Number	J.1
Section	Front Suspension
Sheet	1 (of 1)
Date	January, 1960

Number J.2  
 Section Front Suspension  
 Sheet 1 (of 3)  
 Date January, 1960

### MODIFICATION TO FRONT SUSPENSION

#### 2.4, 3.4 and 3.8 litre Mark 2 Models

FIG. 3

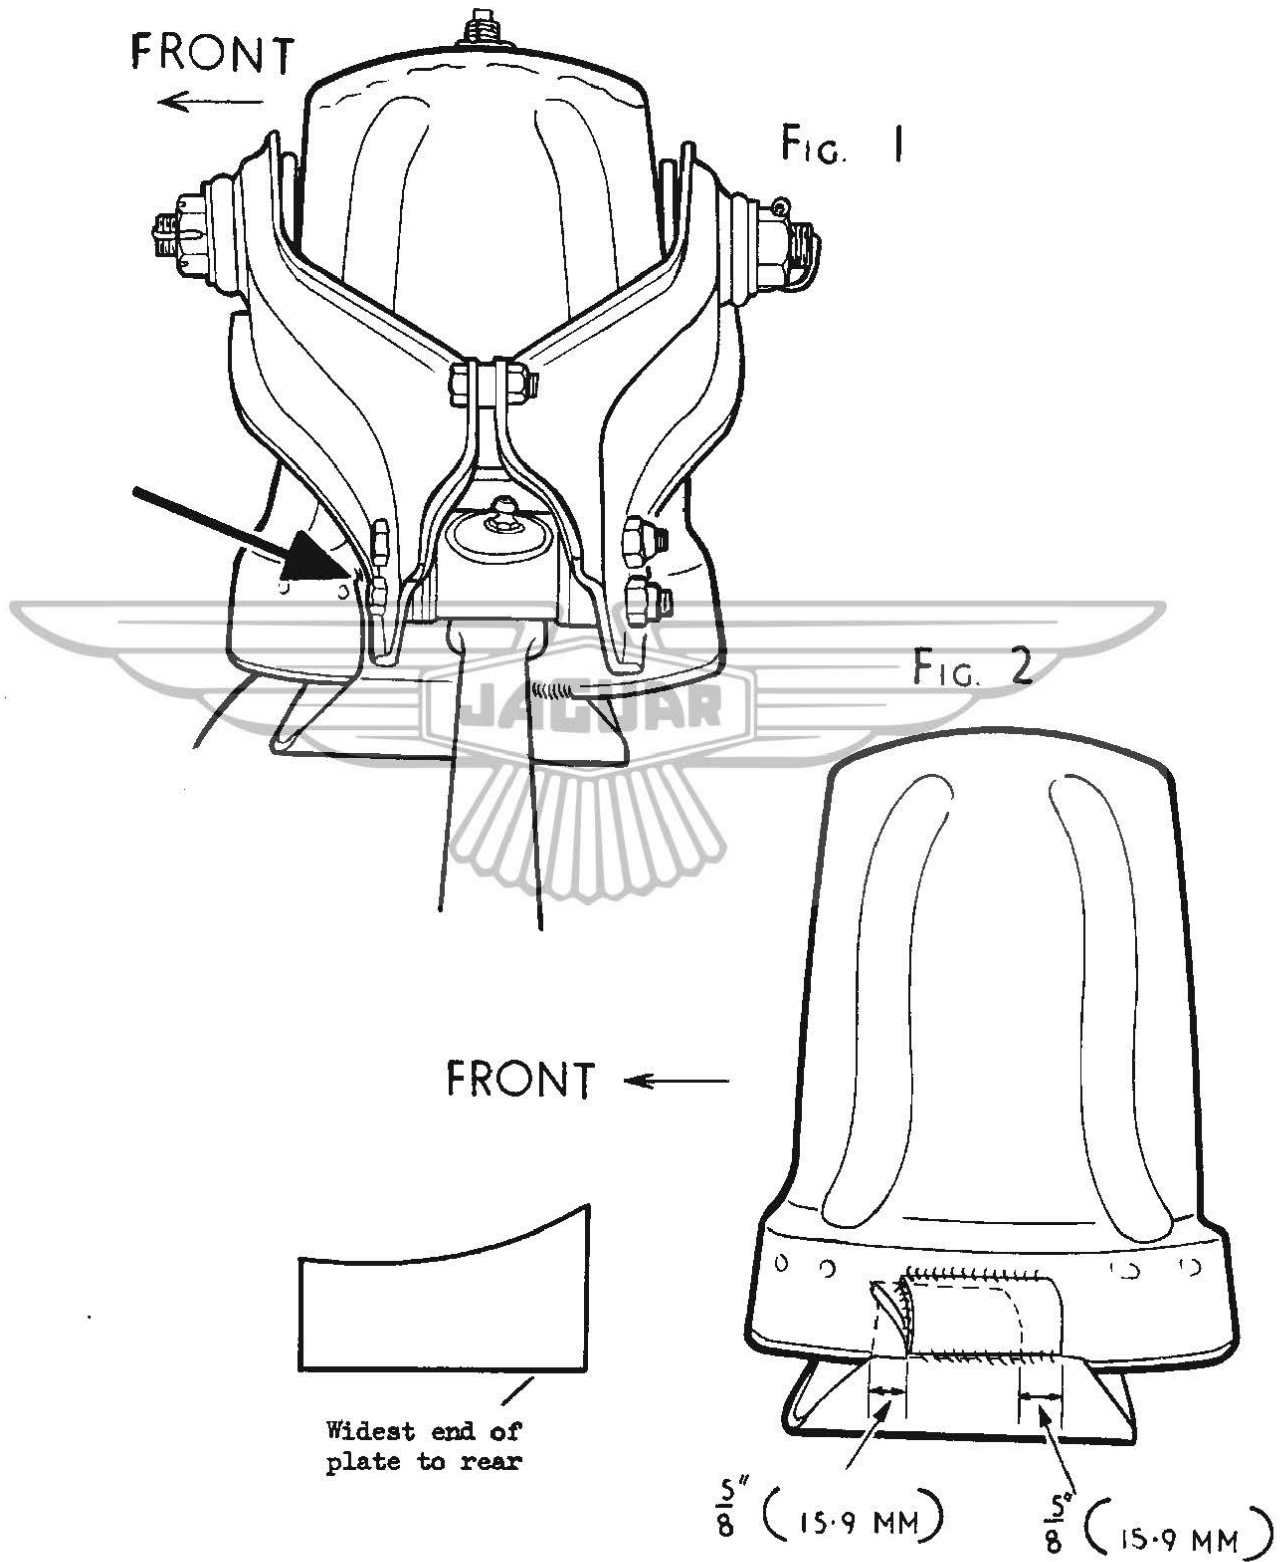
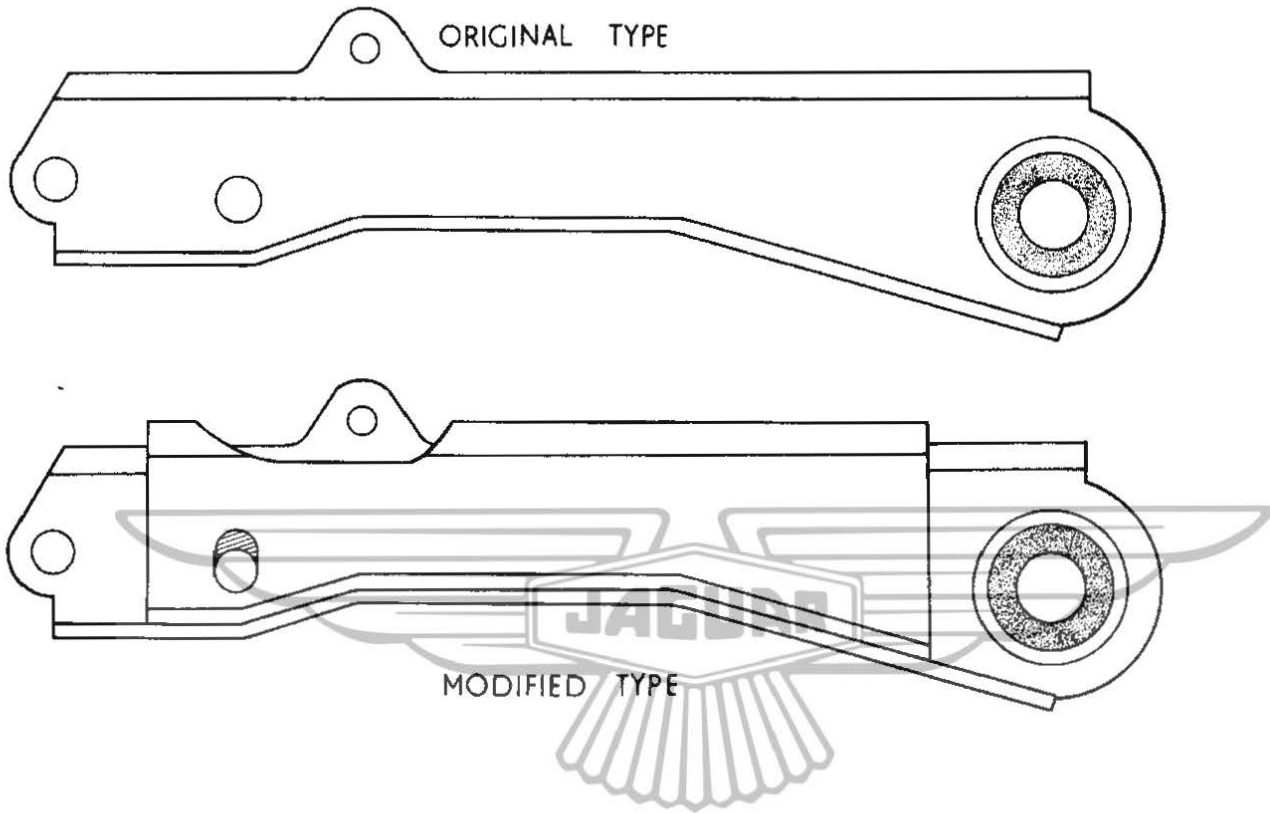
On all cars prior to the chassis numbers quoted above and whether or not the rebound stop plates were fitted correctly in original production the upper wishbone levers are to be changed for the modified type. (see Fig.3.)

<u>Modified type</u>	No. off
C.16798 Wishbone lever	2
C.16799 Wishbone lever	2

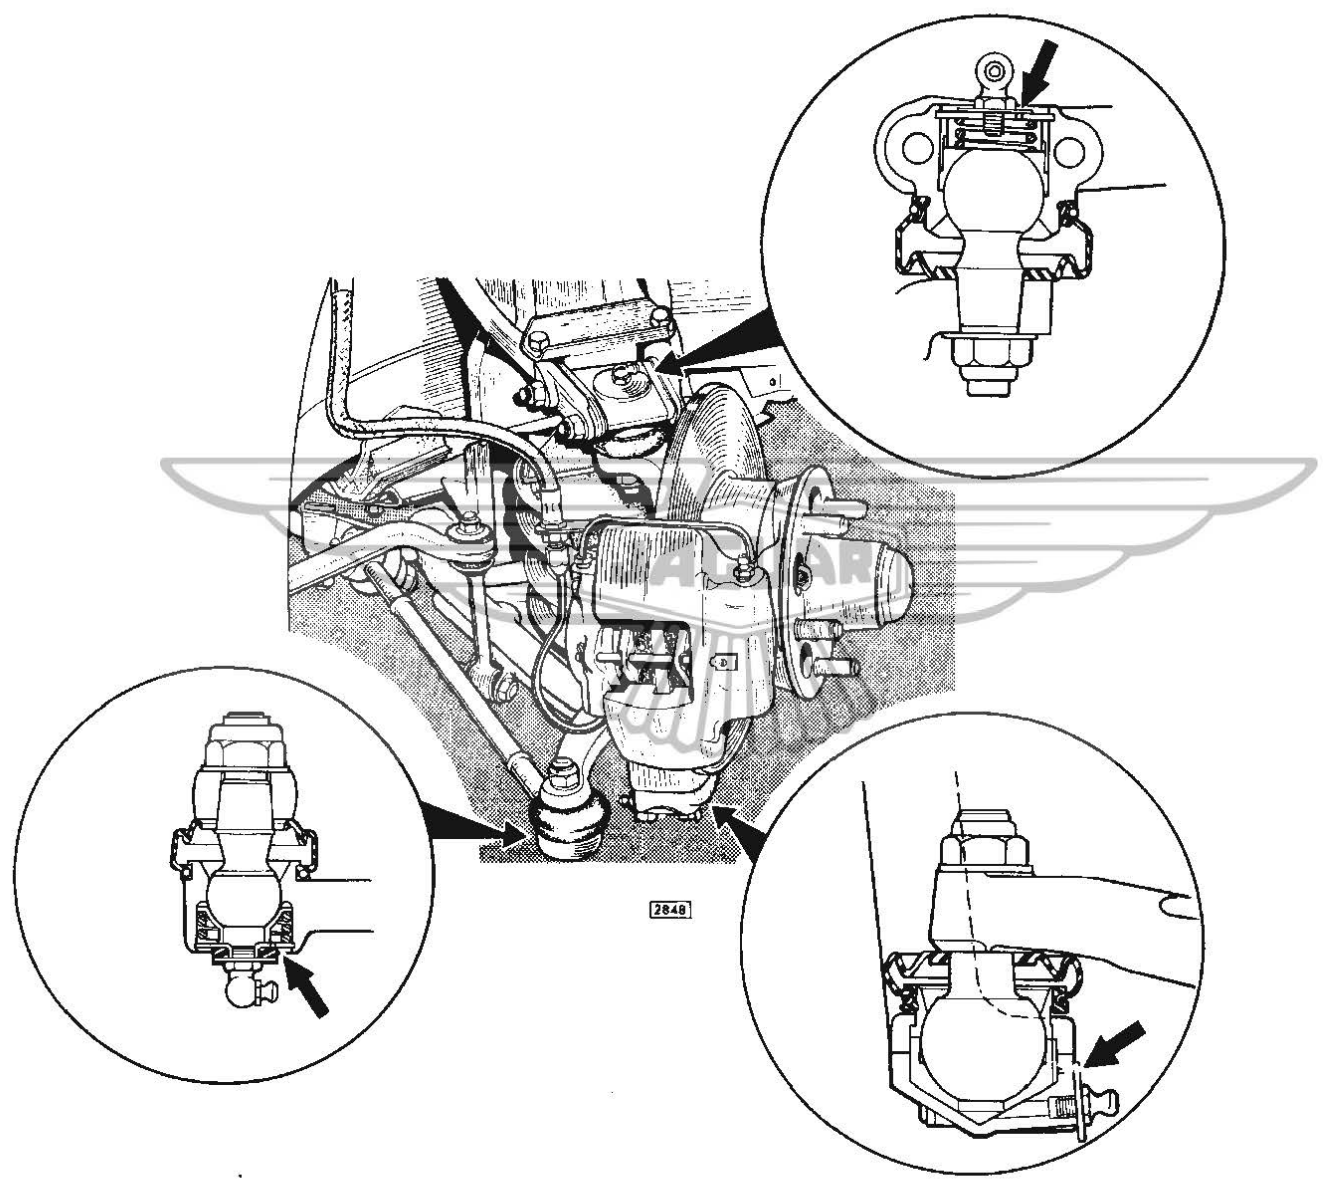
On cars with the above chassis numbers and onwards improved grease seals are fitted to the top and bottom ball joints of the wheel swivels. In conjunction with the fitting of this type of seal a bleed hole is incorporated in the ball joint. The bleed hole is covered by a circular nylon washer which lifts under pressure and allows grease to escape and indicates when sufficient lubricant has been applied (see illustration overleaf). This obviates the tendency for grease to escape past the seals when too much pressure is applied.

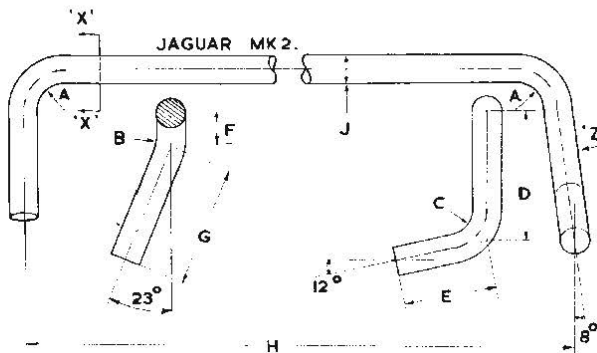
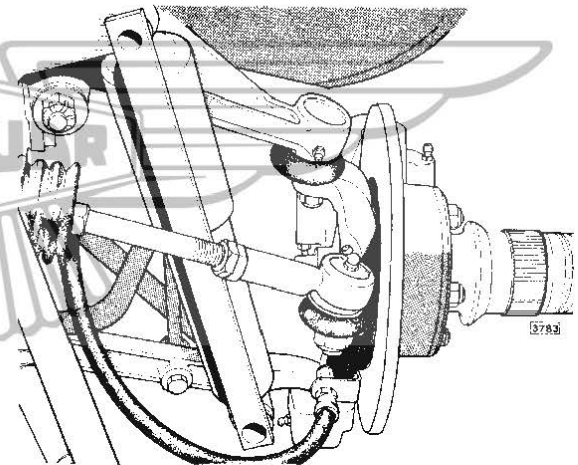
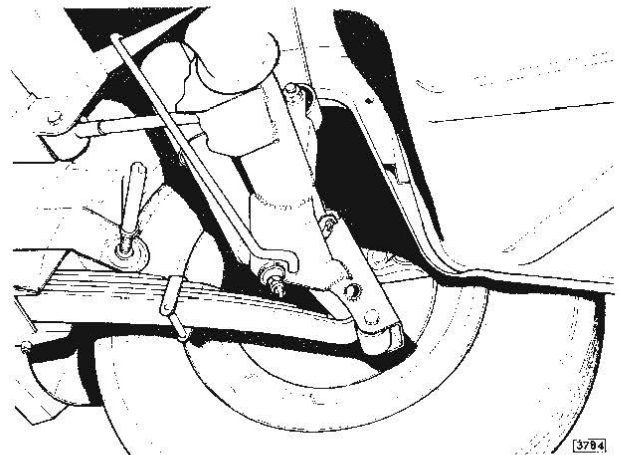
Service Bulletin J.21 (page 3 of 3) incorrectly quotes the length (dimension 'H') of the Rear Suspension Link for Mark 2 cars as 13-7/16" (37.14 cm.).

Please alter your copy of J.21 to read H 13-7/16" (34.14 cm.)

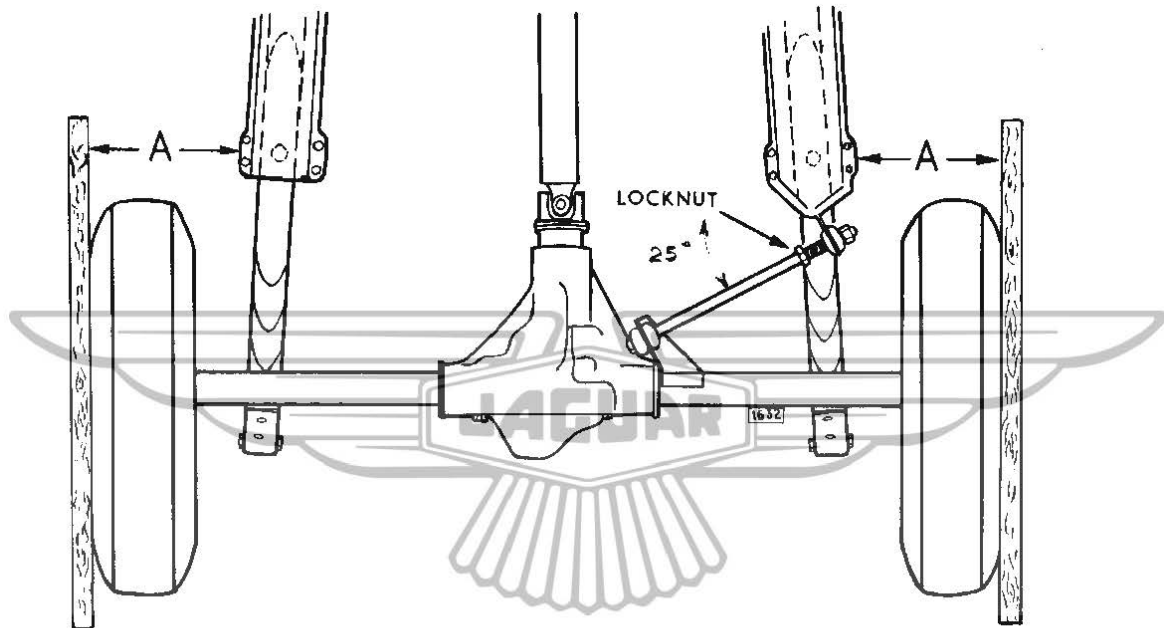
It is pointed out that the original method of setting the Panhard rod by adjusting the rod to a specified length is no longer recommended. The correct method of setting the panhard rod is as follows:-

Place a straight edge across one rear tyre and check the distance to the flange of the chassis side member at the point at which the rear spring centre clamping plate is bolted; repeat for the other side. The point of the chassis side member flange at which the dimension should be taken is between the two bolts which secure the rear spring centre clamping plate.

The dimension at each side (A, in illustration) must be the same. If they are not, adjust the length of the panhard rod until the two dimensions are equal by rotating the panhard rod tube with a pair of grips. Fully tighten the securing nut at the rear axle bracket and recheck the adjustment. Finally, tighten the nut locking the adjusting piece to the panhard rod tube.

### MODIFIED REAR SUSPENSION CROSSBEAM

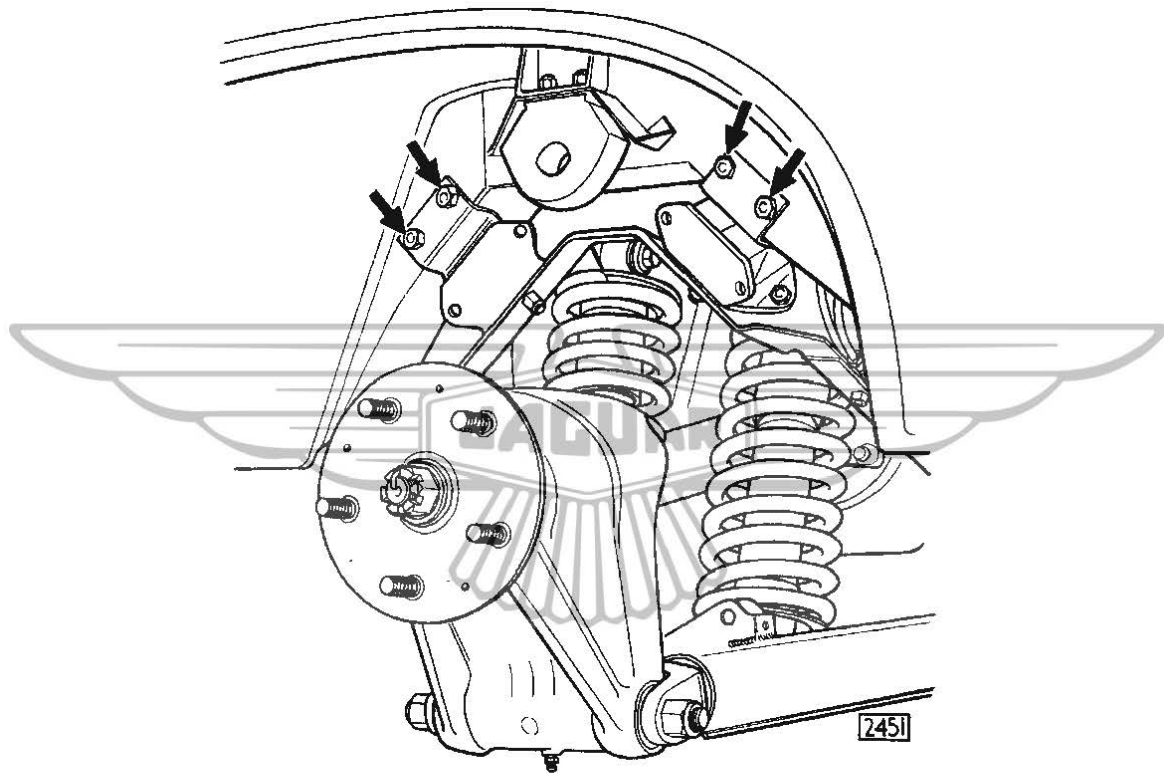
Commencing at the above chassis numbers the mountings, situated at the front and rear of the crossbeam, (see illustration overleaf) are re-positioned.

The new crossbeam (Part No: C.20174) can only be fitted to cars having the modified body rear frame brackets. (See Service Bulletin N.19).
